Planning Application Ref: 21/00517/F Land Drainage Issues in Relation to Your Recent Consultee Comments

Evidencing watercourse mismanagement and silting up

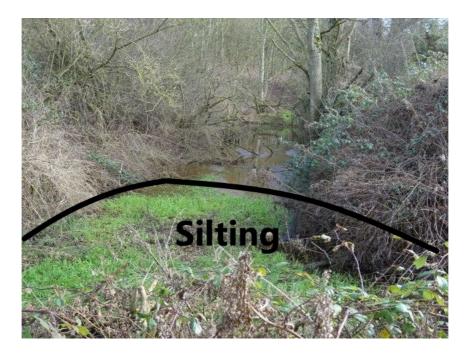
This photo is taken from the bridge on the public footpath at the foot of the start of the MX racetrack. The image shows the much-enlarged pond dug out of the brook, without our or anyone else's consent. As previously explained by us, this pond has been used to irrigate the race track to settle the dust on race days. An enormous gallonage is pumped out using old slurry tankers vacuuming out in excess of 1500 gallons per tanker load to dampen the track. This water extraction is massively above the legal limit to abstract without a licence.

The much enlarged pond in the brook has now not been used for irrigation purposes for some three years. Hence, the pond is now very choked with silt, which has been washed into the brook from the bare race track. The silted areas have grass rooting and growing on them, severely impeding the flow of the brook.
